Site Plan Review Committee (SPRC) Virtual Meeting

July 11, 2022

Crystal Plaza 5 – 2250 Crystal Drive / 223 23rd Street S.

New Site Plan, Rezoning, and PDSP and Site Plan Amendments

223 23rd Street

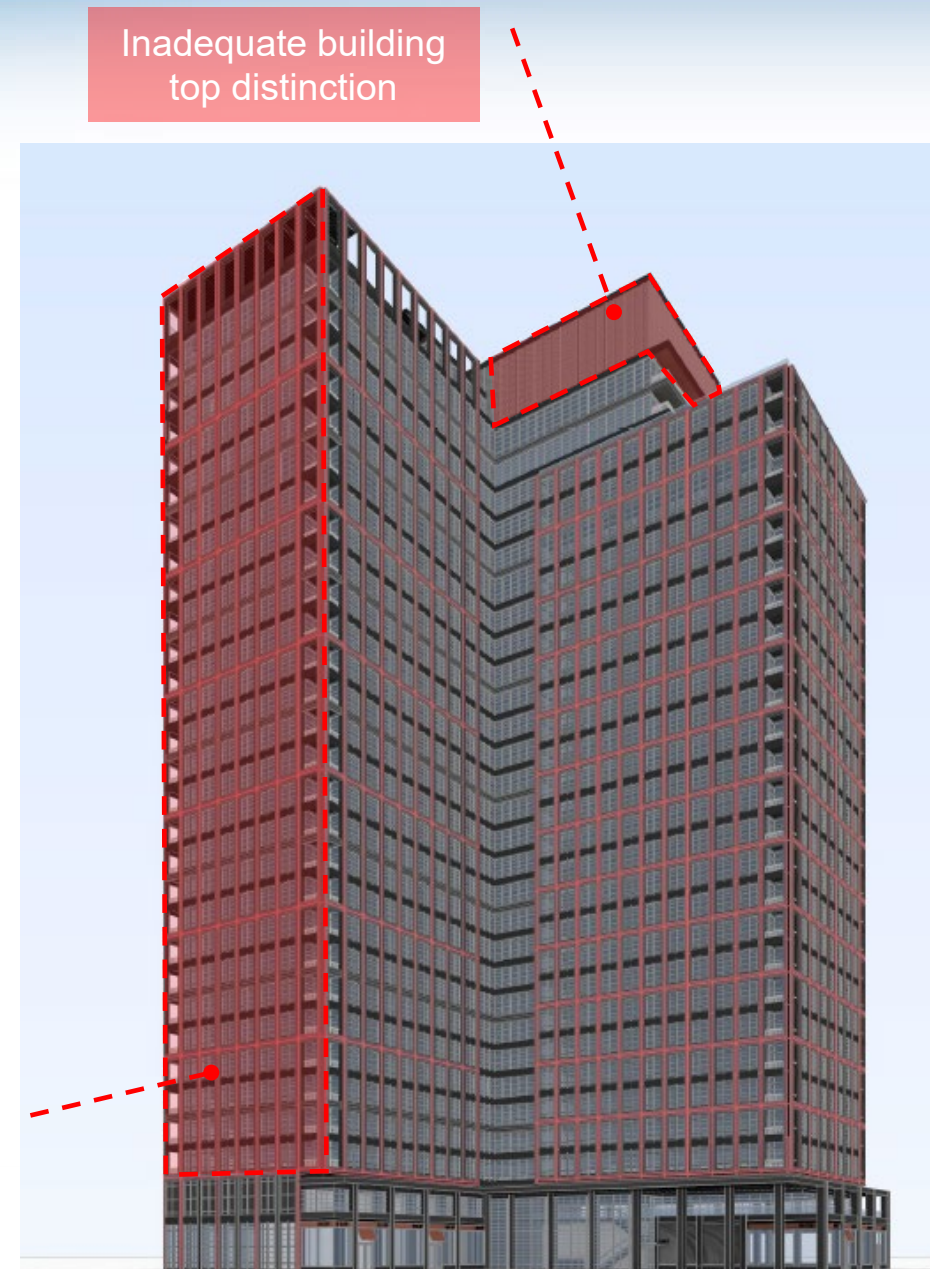
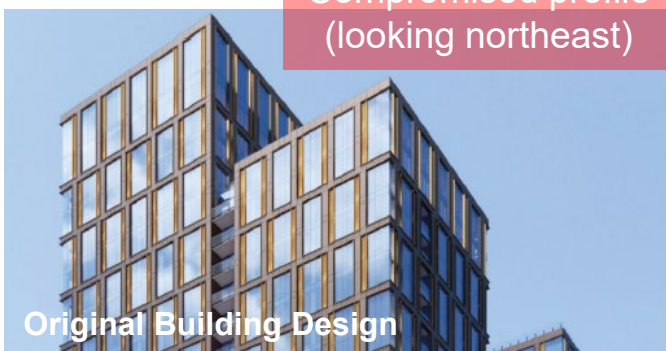
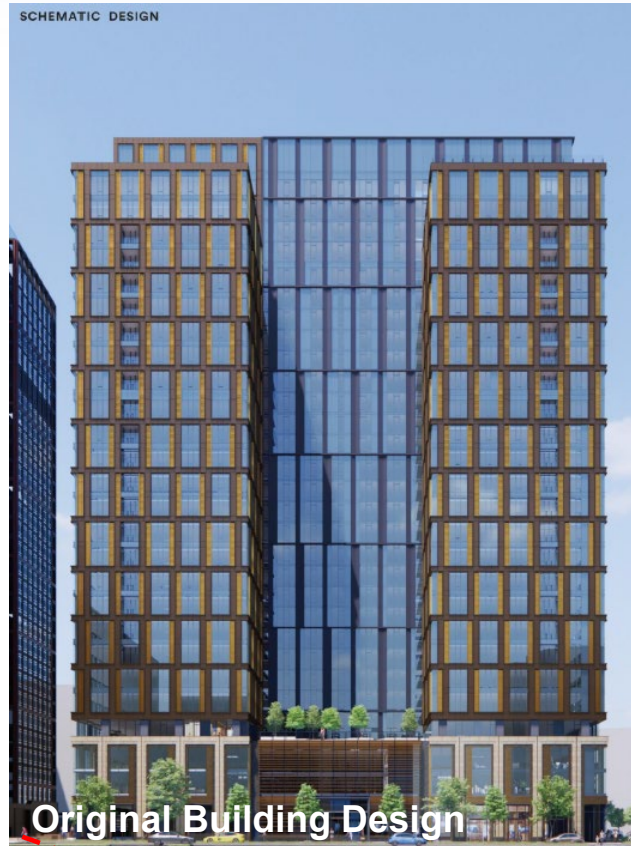
- Tower step-back not introduced on west building façade that will front a future Clark-Bell Street
- Building top (mechanical penthouse) not adequately integrated as part of the overall building design, with no degree of sculpting to set it apart from the rest of the building

No tower step-back along future street

Inadequate building top distinction

Retail Frontages and Underground Access

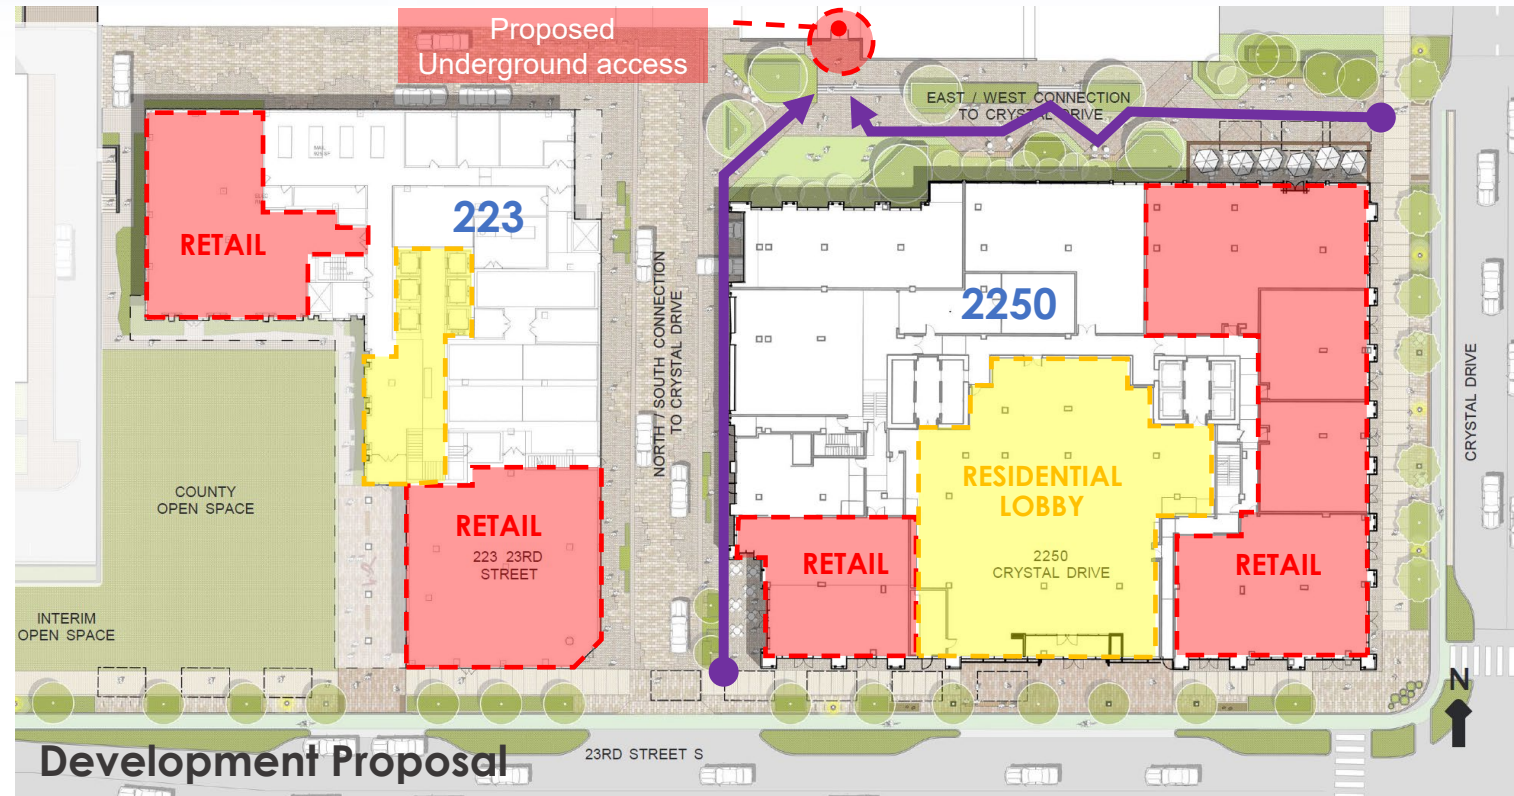
- Retail use now proposed at the North side of Open Space #10
- Pedestrian access to the Underground will be provided:
 - Through the new internal north-south connection
 - Through the proposed Open Space #11 plaza

Public Open Space

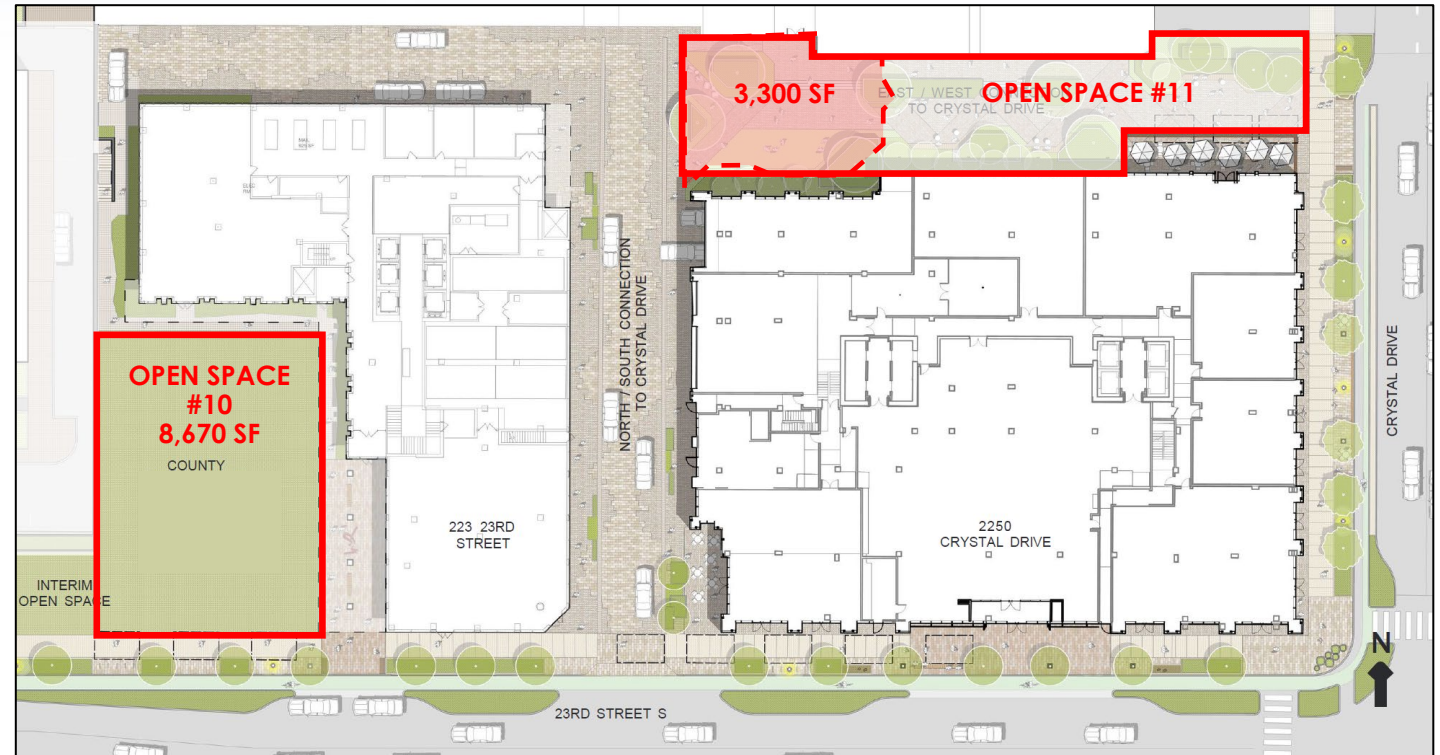
- The applicant is proposing a phased Open Space #10 with an initial phase that is 33% smaller than the 13,000 sf called for in the Sector Plan
 - The initial phase would be designed and constructed as part of this site plan review
 - The final phase would be subject to a future development application and a separate public review process
- Space #11 is proposed in an alternative location; however, the total space provided is significantly larger than the 3,300 sf called for in the Sector Plan
 - This plaza area will be designed and constructed as part of this site plan review

- Recommendation: the initial phase for Open Space #10 should incorporate additional design details for the 8,670 sf space:
 - Consider less intensive landscaping to frame the space and add interest (compared to the simple grass lawn area proposed)
 - Contemplate pedestrian paths; both to rear retail frontage and to stairs (on the northwest side of the side) providing access to the interior of the block
